Office Action Summary	Application No. 10/668,734	Applicant(s) TOBEN ET AL.
	Examiner ERNESTO GARCIA	Art Unit 3679

DETAILED ACTION

Grimaldi, EP-71,586

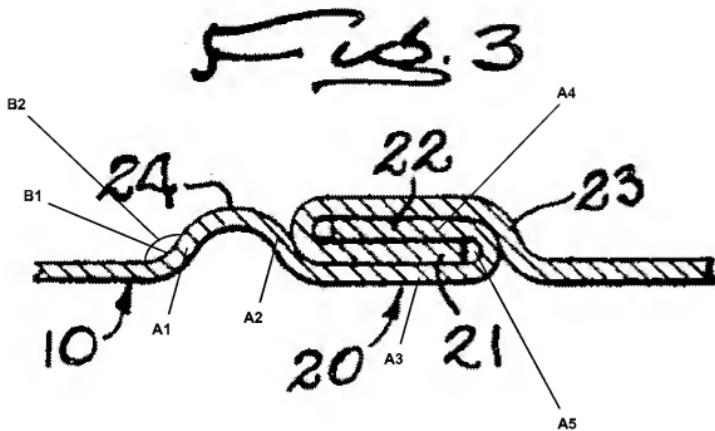
Regarding claim 20, Grimaldi discloses, in Figures 1 and 5, a method comprising: integrally forming a female end portion **3** at another distal end of a duct wall **1**; and,

bending a first fold **A1** (see marked-up attachment) beginning at a break point **B1** of the duct wall **1** to extend at a hemmed angle **B2** towards an interior of a ductwork (since portion 3 points inwardly in Figure 1, the fold A1 points inwardly as well);

bending a second fold **A2** back upon the first fold **A1** to extend substantially adjacent to the break point **B1**;

bending a third fold **A3** beginning substantially adjacent to the break point **B1** and extending substantially parallel to the duct wall **1**; and,

bending a fourth fold **A4** back against the third bold **A3** to define a groove **A5**.
